## Non-Concurrence Process Record for NCP-2012-001

NCP TRACKING NUMBER  
NCP-2012-001

TITLE OF SUBJECT DOCUMENT DIABLO CANYON POWER PLANT - INSPECTION REPORT 05000275/323-2011005		ADAMS ACCESSION NO. <i>ML 120450843</i>
DOCUMENT SIGNER Neil O'Keefe,		SIGNER PHONE NO. (817) 200-1141
TITLE Chief	ORGANIZATION Project Branch B, Region IV	
NAME OF NON-CONCURRING INDIVIDUAL(S) Michael Peck		PHONE NO. (805) 595-2354
TITLE Senior Resident Inspector	ORGANIZATION Project Branch B, Region IV

**Background:** The purpose of this document is to provide detailed comments and context associated with Non-concurrence Package 2012-001 (ADAMS ML12151A173) because the topics discussed in NCP-2012-001 were complex and not fully explained. The action taken in response to NCP-2012-001 was to indicate that the NRC would address the operability question through a change to the current licensing basis, not through the enforcement process as proposed. However, as the branch chief responsible for Diablo Canyon Power Plant, I felt it was important to provide additional information on some of the details raised in NCP-2012-001 so that readers would have additional perspective on the issues and be able to reco

Figure 1  
 Comparison of DE, DDE, & HE Horizontal Response Spectrum at the Steam Generators

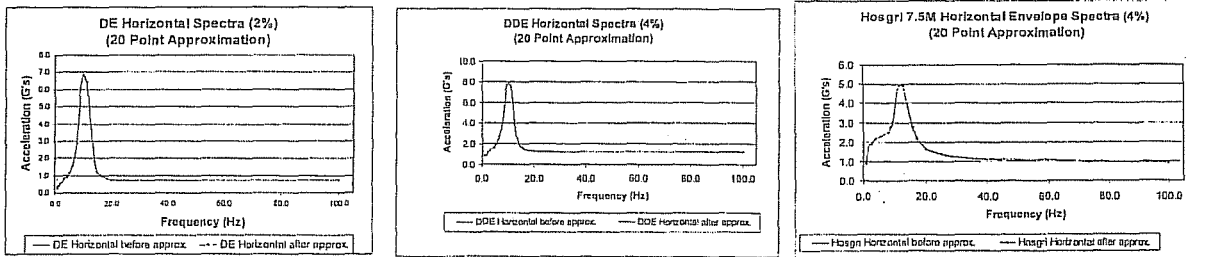
The licensee's substitution of the HE design basis for demonstrating the DDE Code acceptance criteria were met was not an acceptance approach by either the licensee's operability procedure or the NRC operability guidance. This was a concern because in many cases, the reactor coolant pressure boundary stress was more limiting for the DDE than HE (see Figure 1).

**Comment [n10]:** The data in this graph was not verified as part of our review. However, the reader should understand that the three curves used different ground motion and different damping values in the separate calculations. As a result, the curve that used the largest ground motion shows the lowest acceleration. This demonstrates that the output of the calculations are sensitive to the damping value approved by the NRC.

Figure 2  
Comparison of DDE and HE Containments Floor Response at 88 Foot

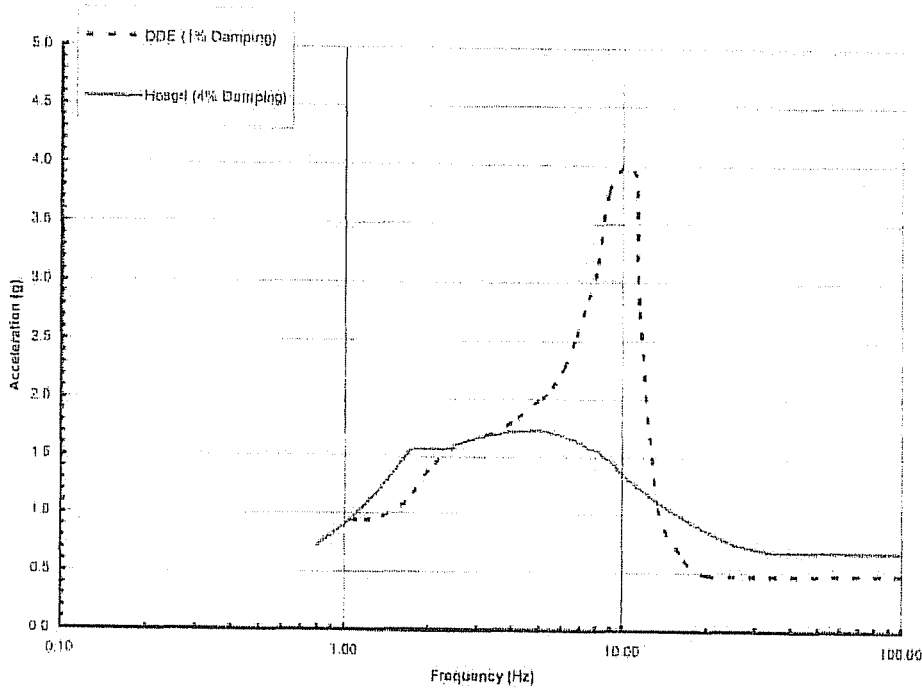
In many cases the DDE safety analysis provided the bounding vibratory motion used to establish the seismic qualification for plant SSC. For example, the FSARU credited the containment fan coolers to mitigate the design basis loss of coolant and steam line break accidents. The design basis required these coolers to be qualified to function following the vibratory motion (shaking) associated with the DDE. These coolers are located on the 88 foot level of the containment building. As shown in Figure 2, the DDE vibratory motion was greater than HE at this location. The POD was inadequate because the licensee failed to

**Comment [n12]:** The data in this graph was not verified as part of our review. However, the reader should understand that the two curves used very different damping values in the separate calculations. As a result, the curve that seems to show the larger acceleration is associated with much lower ground motion than the other curve. A comparison of the two curves shown is not meaningful except to illustrate that the DDE can produce much larger calculational results than the much larger Hosgri Earthquake because the DDE used very conservative calculational values.
